| | Work Order ID 79018 <i>January-18-12 1:53:55 PM</i> | | | | | *79 | N18* | | | | | | Page 1 |
|---|--|-----------------------------|--------------|-------------------|-------------|------------------------------|---------------------|-------------|--------------|---------------|-------------------|------------------|----------------|
| Revision ID: | D407-667-20 Crosstube Aft | | | | | Accept | *N90 | 0040 | 100 |)* s | etup Star Stop | 1.71 | S1* S2* |

| DART AEROSPACE LTD | Work Order: | 79018 |
|---------------------------------------|--------------|--------------|
| Description: Crosstube High Aft (407) | Part Number: | D407-667-205 |
| Inspection Dwg: D407-667-245 Rev: F | | Page 1 of 1 |

| DRAWING NO. D407-667-245 | TITLE CROSSTUBE ASS | REV. F Y (407 HIGH AFT) | DART AEROSPACE L' ENGINEERING ORDE | | SHEET NO. SHEET 1 OF 2 | SCALE NTS |

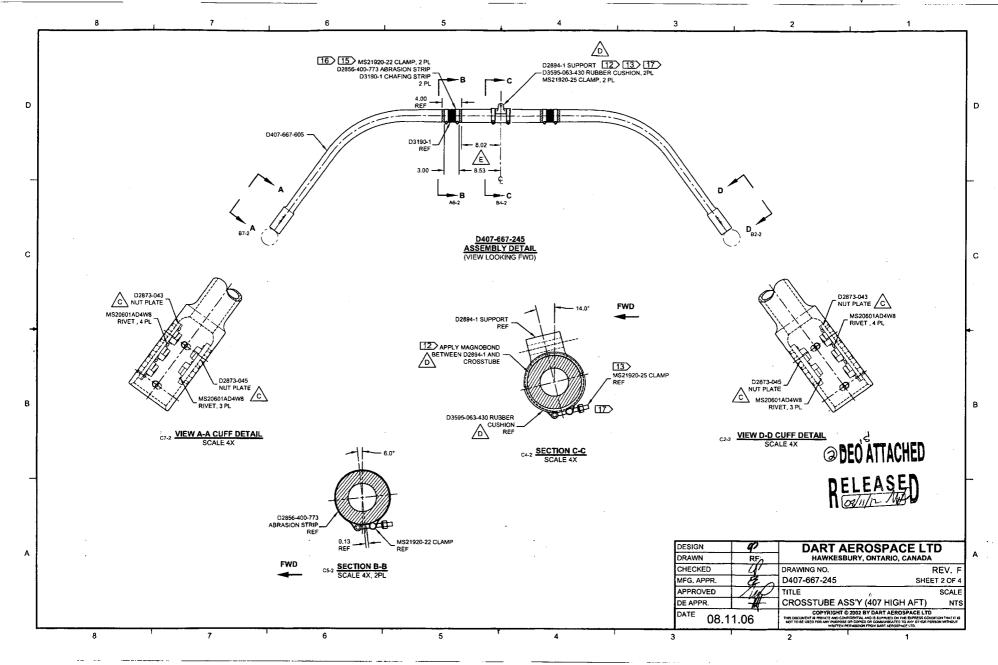
PURPOSE:

REMOVED ABRASION STRIP IN FAVOR OF A THIN LAYER OF PROSEAL 890.

PARTS LIST IS AMENDED AS FOLLOWS:

<u>IS:</u>

| Item | Qty -245 | Part Number | Description |
| 3 | 0 | D2856-400-773 | ABRASION STRIP |

WAS:

| _ 3 | 2 | D2856-400-773 | ABRASION STRIP |

NOTES 2 AND 15, SHEET 1 ARE AMENDED AS FOLLOWS:

<u>IS:</u>

- 2) FINISH: CHEMICAL CONVERSION COAT PER DART QSI 005 4.1
 PRIME INSIDE AND OUTSIDE PER DART QSI 005 4.2
 MASK UNDERSIDE OF CROSSTUBE AS SHOWN (HATCHED AREA) AND PAINT OUTSIDE PER DART QSI 005 4.2
 REMOVE MASKING AND APPLY CLEAR COAT
- 15) APPLY A THIN COAT OF PROSEAL 890 ON INSIDE CONCAVE SURFACE OF D3190-1 CHAFING SHIELDS AND LET CURE PER MANUFACTURER'S INSTRUCTIONS. INSTALL PROSEALED D3190-1 CHAFING SHIELDS ONTO CROSSTUBE BY APPLYING A THIN COAT OF PROSEAL 890 ONTO CROSSTUBE. BE SURE TO ELIMINATE ANY AIR GAPS.

WAS:

- 2) FINISH: CHEMICAL CONVERSION COAT PER DART QSI 005 4.1
 PRIME INSIDE AND OUTSIDE PER DART QSI 005 4.2
 PAINT OUTSIDE PER DART QSI 005 4.2
- 15) INSTALL D2856-400-773 ABRASION STRIP WITH A 0.13 REF GAP ON BOTTOM SIDE OF CROSSTUBE PER QSI 035.

| DRAWING NO. | TITLE | REV. F | DART AE | ROSPACE LTD | D.E.O. NO. | SHEET NO. | SCALE |

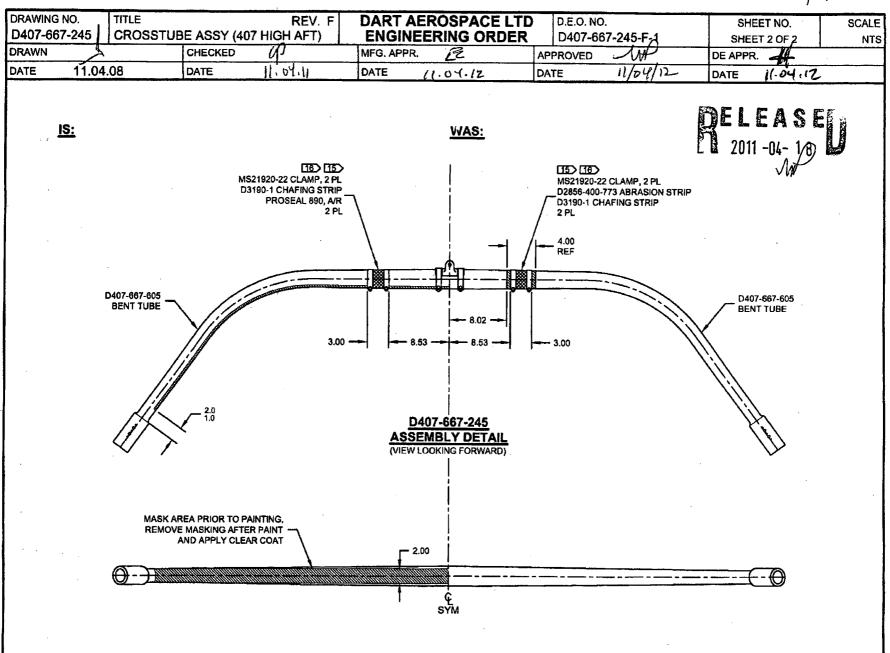
PURPOSE:

REPLACE MAGNOBOND WITH 3M DP460 SCOTCH-WELD EPOXY ADHESIVE

IS:

| Item | Qty -245 | Part Number | Description |
| 12 | A/R | SCOTCH-WELD DP460 | EPOXY ADHESIVE, 3M SCOTCH-WELD |

WAS:

| 12 | A/R | ROCKWELL SPECIFICATION RBO-120-023 |
